## Response to RC1

We are grateful to your careful review and constructive suggestions on our manuscript. These comments are valuable and helpful, and we have thoroughly revised the manuscript in response to all the comments. Below are our point-by-point responses (blue color) and the changes we've made to the manuscript (in italic).

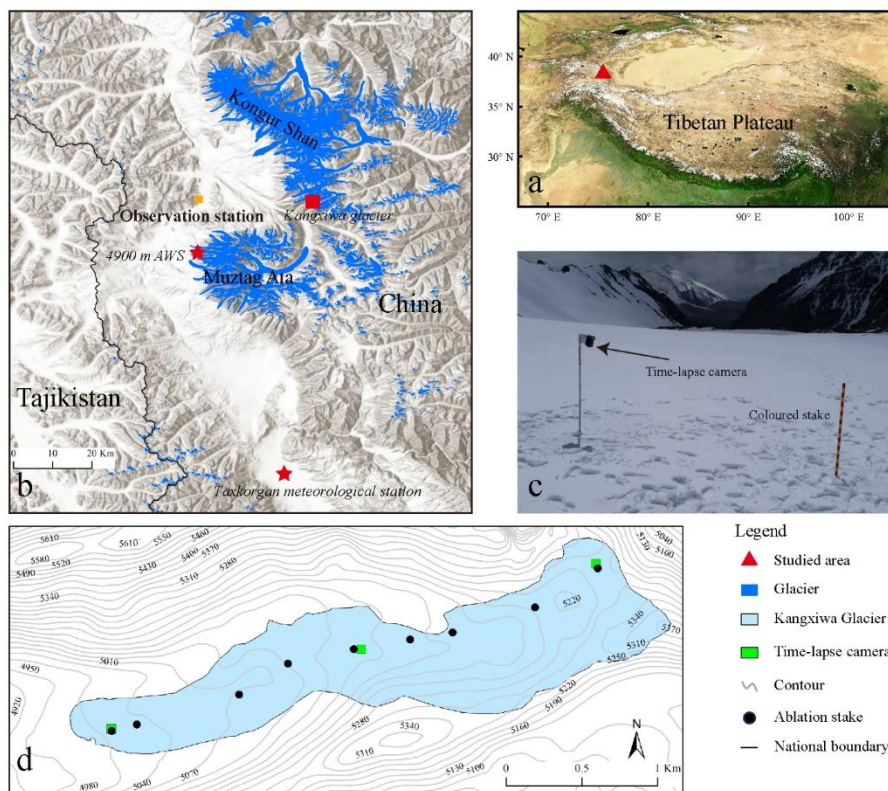
1. The first comment is based on the author's response: Fig 1R: I only see 9 mass balance points, not 10. Please check this.

Response: Sorry for the mistake on our part. There are 9 mass balance points for the period 2019/2020–2022/2023 (please also refer to the dataset provided in our previous response document). Starting from the 2023/2024 season, 10 ablation stakes have been installed on Kangxiwa Glacier. We previously misidentified their locations, and have now corrected both Figure 1d and the corresponding text in the revised manuscript.

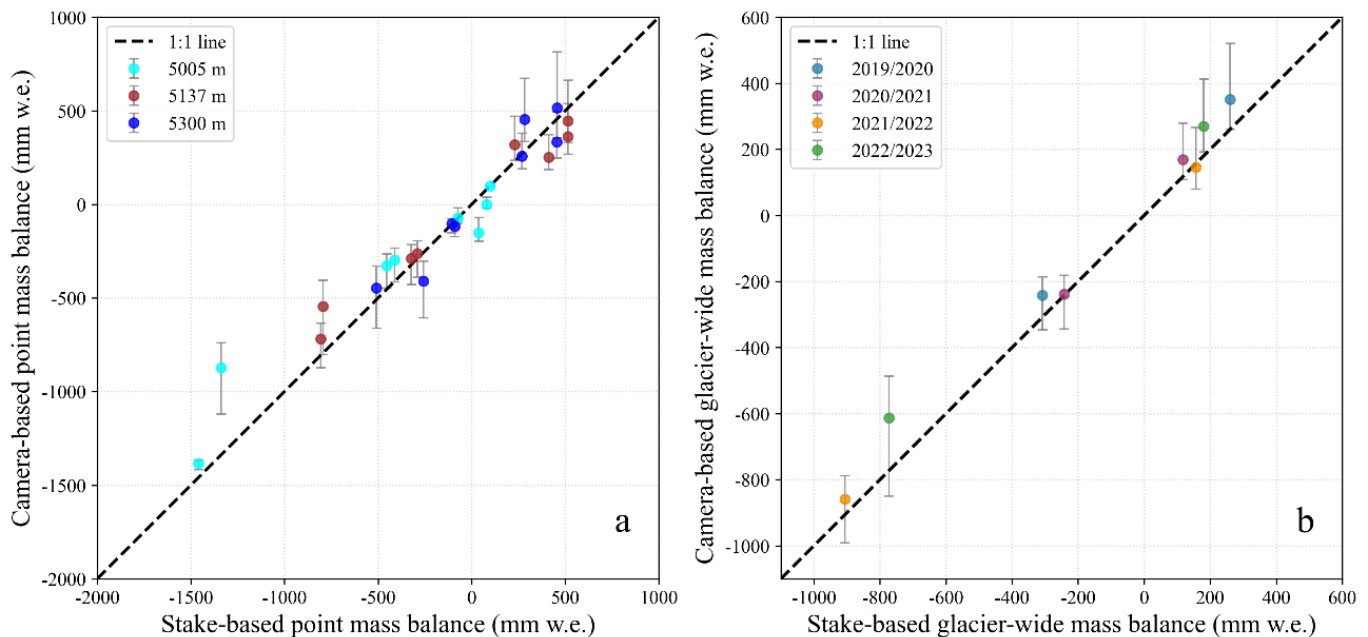
8. Fig 4: consider using different colors for the stakes at different altitudes in Fig 4a and different colors for the different hydrological years in fig 4b. Also, the extend of the axis is annual mass balance, compared to the start of the hydrological year, right?

Fig. 4 caption: explain the derivation of the uncertainty bounds and their meaning here.

Response: Figure 4 was modified following your suggestion. The data shown in Figure 4 represents seasonal mass balances which were derived from in-situ and camera measurements. We have added “seasonal” in the figure caption accordingly.

Response: The meaning and derivation of the uncertainties were added to the caption: "*The vertical bars represent the uncertainty bounds of camera-derived results which were derived from the minimum and maximum snow densities, respectively.*"

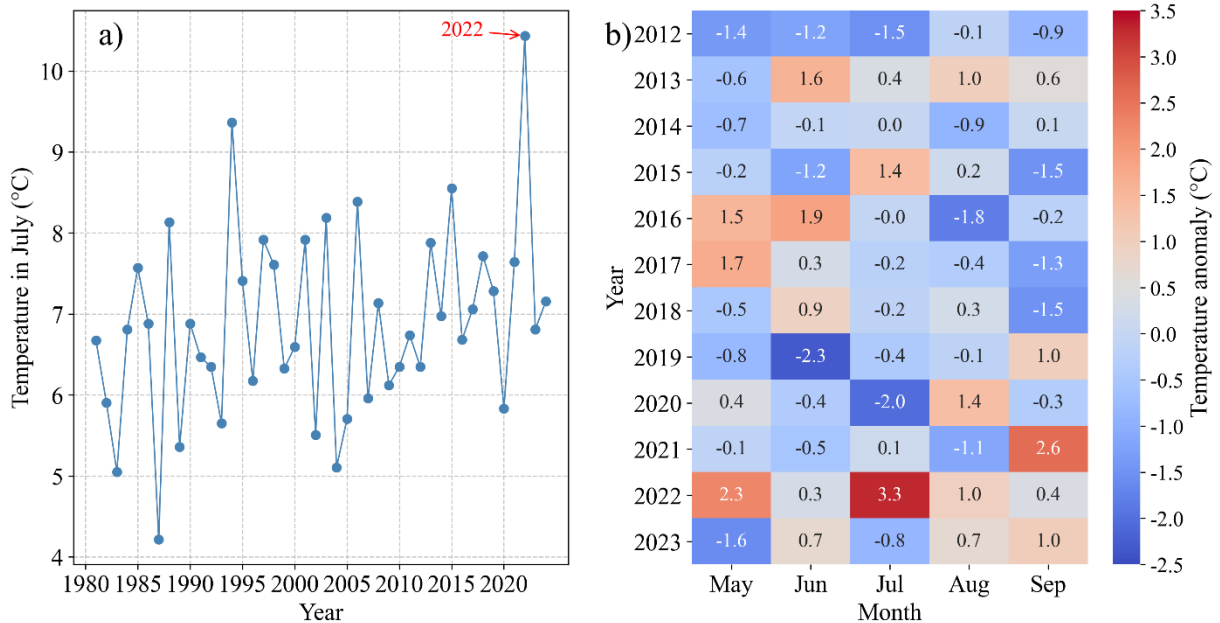
13. Fig 6: please add a label to 2022 in this plot, so it is directly clear to the reader that this year was very anomalous.

Response: 2022 is clearly visible in the heatmap of Fig. 6b, we added a label in Fig. 6a to highlight 2022 for the reader.
